FMB140 Product Change Notifications

Product change notifications (PCN) is the way of informing customers of upcoming changes related to Teltonika products. This includes outward appearance adjustments, hardware improvements, firmware changes, changes to package contents, etc. This page stores information regarding changes to the FMB140 tracking device. Below you will find a list of both upcoming and already implemented changes sorted from newest to oldest (top to bottom).

2021.04.16: Top Laser Printing Changes

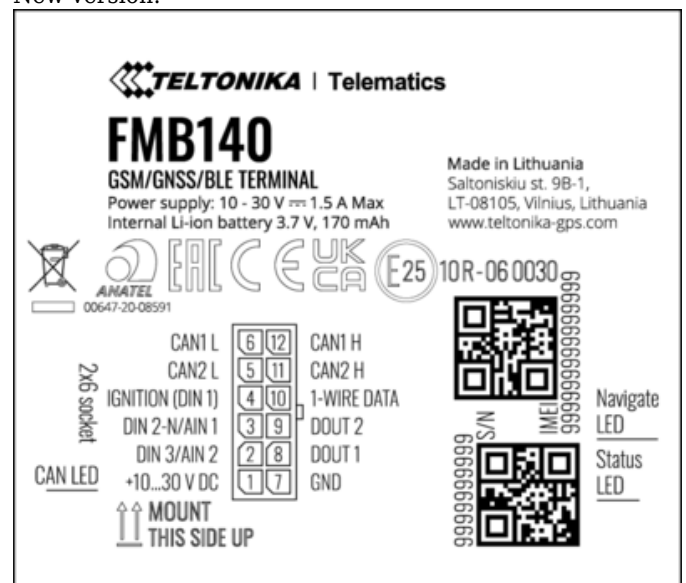
Change type	External/visual
	Top laser printing design changed

Change reasons 1. Added ANATEL label and certificate number.
 Product release date April 2021
